FAQ Number 10-0059 **FAQ Revision** 2

FAQ Title NFPA 805 Monitoring

| Plant: | <u>Harris Nuclear Plant</u> | Date: | <u>August 19, 2011</u> |

Figure E-1 – NFPA 805 Monitoring Process

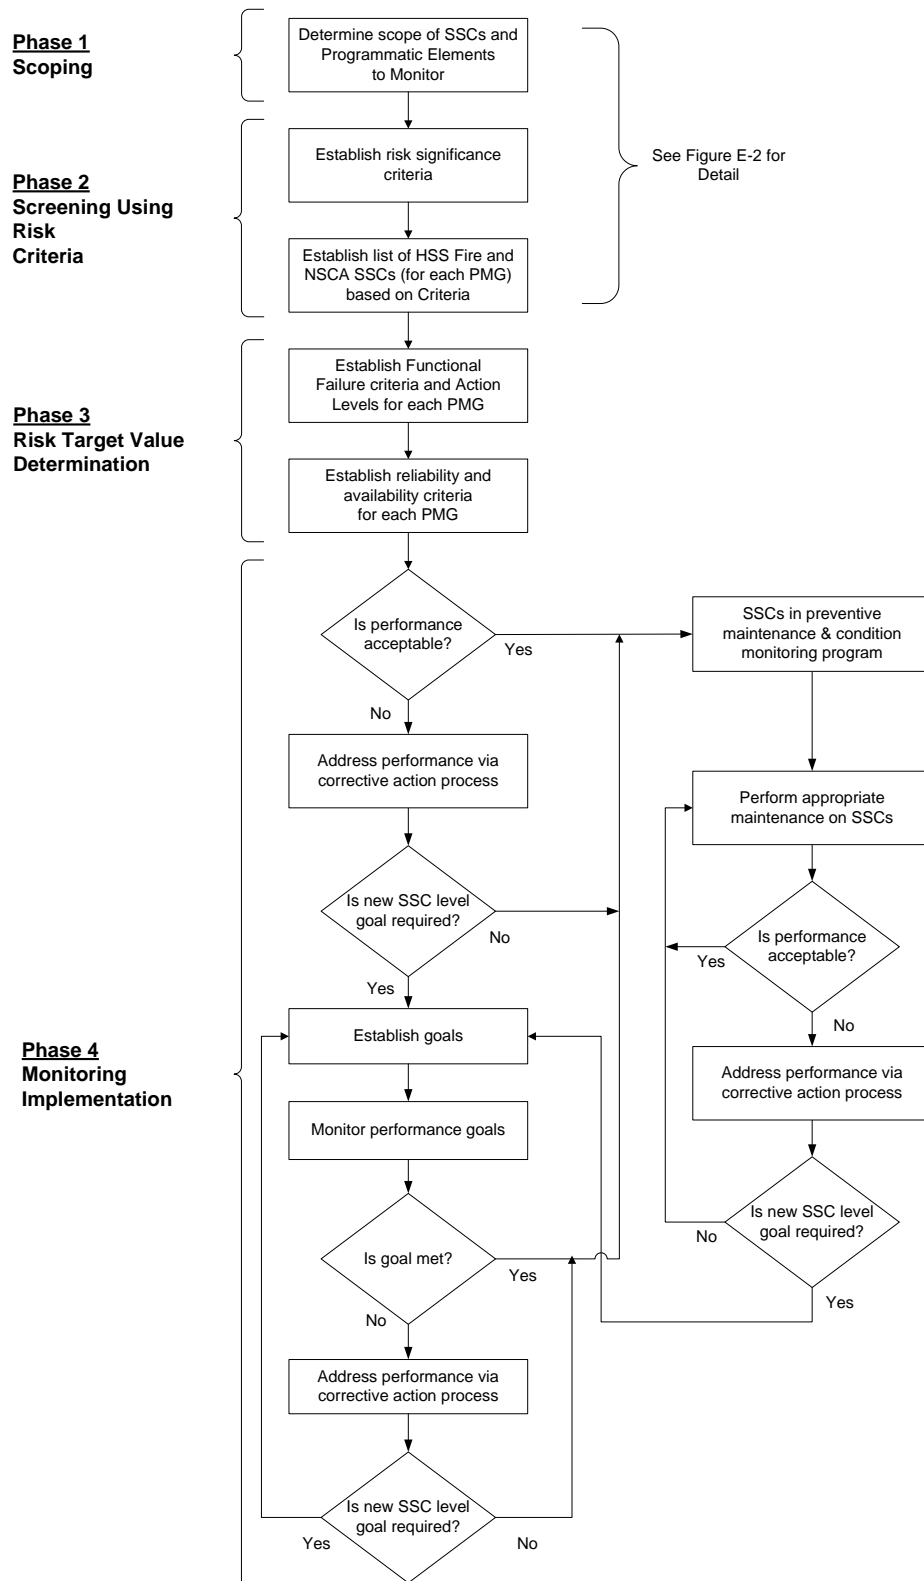
REPLACE ALL OF APPENDIX E WITH THE FOLLOWING:

A suggested methodology is outlined below. Figure E-1 provides an overview of the Monitoring Process, while Figure E-2 provides detail on a process for Phases 1 and 2.
